**Response to the “Approval with Modifications, Phase II Investigation Work Plan for
Consolidated Unit 21-016(a)-99, Material Disposal Area T, at Technical Area 21,
Los Alamos National Laboratory, EPA ID #NM0890010515, HWB-LANL-06-017,”
Dated June 7, 2007**

Figure 1 Plan view showing borings and transect lines around former building 21-035

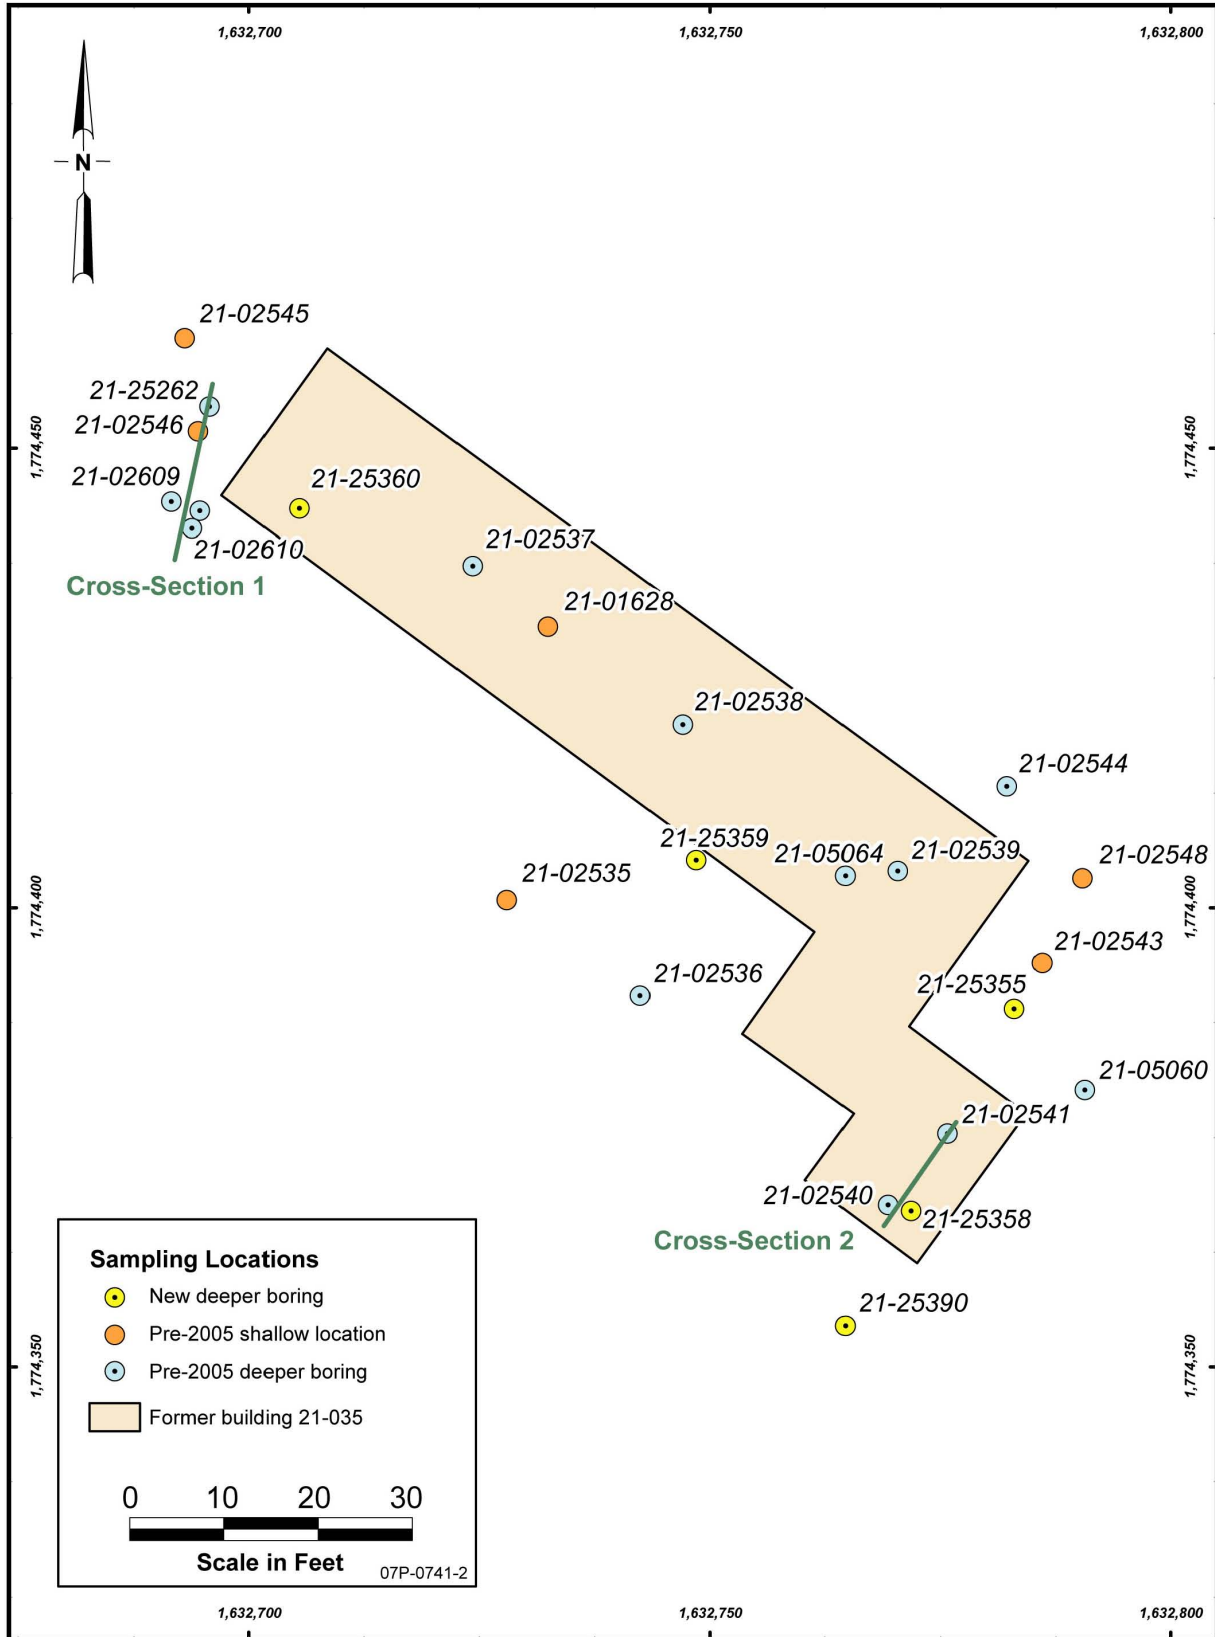
- 3. In required action #7, NMED directed the resampling of certain boreholes to determine the vertical extent of americium-241. In their response, the Permittees state that the extent of americium-241 is defined with nearby deep boreholes. NMED disagrees with this statement for four of the eight locations.*

The first three locations (21-02547, 21-25609 and 21-02610) are not defined by the deep borehole 21-25262 because these three boreholes are located within a small area that contains several SWMUs and AOCs and 21-25262 is located outside of this area. These SWMUs and AOCs consisted of underground storage tanks, manholes, an aboveground storage tank, and other tanks, as described in the "TA-21 Operable Unit RFI Work Plan for ER." According to the "MDA T Historical Investigation Report," these SWMUs and AOCs were the location of detected contamination during drilling in 1994. Americium-241 was detected in a sample collected from a 5-10 foot interval. Because it is not clear that the detected contamination is attributable to the bottom of the sampling interval (e.g., contamination at 5 feet or 10 feet) and the vertical extent of contamination in this small area has not been defined, the Permittees must drill an additional borehole close to 21-02547. The Permittees must collect a sample from the 8-10 foot interval and additional samples at deeper intervals in the tuff until the extent of contamination is defined. In order to define the extent of contamination, the Permittees should analyze these samples for americium-241, plutonium-238, plutonium-239, and strontium-90.

Contamination at the fourth location (21-02541) is not defined by locations 21-02540 and 21-25358. Americium-241 and plutonium-239 were detected at elevated concentrations in borehole 21-02451 at 10-12.5 feet. The sample collected from borehole 21-02540 was collected from 7.5-10 feet. The samples collected from borehole 21-25358 were collected at 6.8-7 feet and 38-40 feet, respectively. Also, the concentrations of several constituents (americium-241, cesium-137, plutonium-238, plutonium-239, strontium-90 and tritium) increase with depth in borehole 21-02541. To adequately determine extent of contamination, the Permittees should have collected samples starting at 12.5 feet at these locations. The Permittees must adequately define vertical extent of contamination in this borehole by collecting a sample starting below the 12.5-foot interval and additional samples at deeper intervals until extent is defined. The Permittees should analyze these samples for americium-241, cesium-137, plutonium-238, plutonium-239, strontium-90, and tritium.

3. The nature and extent of americium-241 have been defined in all eight of the boreholes. The nature and extent for americium-241 at the first three sampling locations (21-02547, location 21-02609 [not 21-25609], and 21-02610) (Figures 1 and 2) are defined, because deep borehole 21-25262 is 380 ft deep and approximately 12 ft away horizontally from the other three locations. Any deeper contamination from the three sampling locations would have been intercepted by sampling at 21-25262. Only very low radionuclide concentrations were detected. The nature and extent of americium-241 at the fourth location (21-02541) have also been determined at locations 21-02540 and 21-25358 because borehole 21-25358 is 40 ft deep and is approximately 12 ft away horizontally from the other two locations. Any deeper contamination from the two sampling locations would have been intercepted by sampling at location 21-25358. Only very low tritium concentrations were detected in that borehole. The two new figures included with this response clarify these relationships.
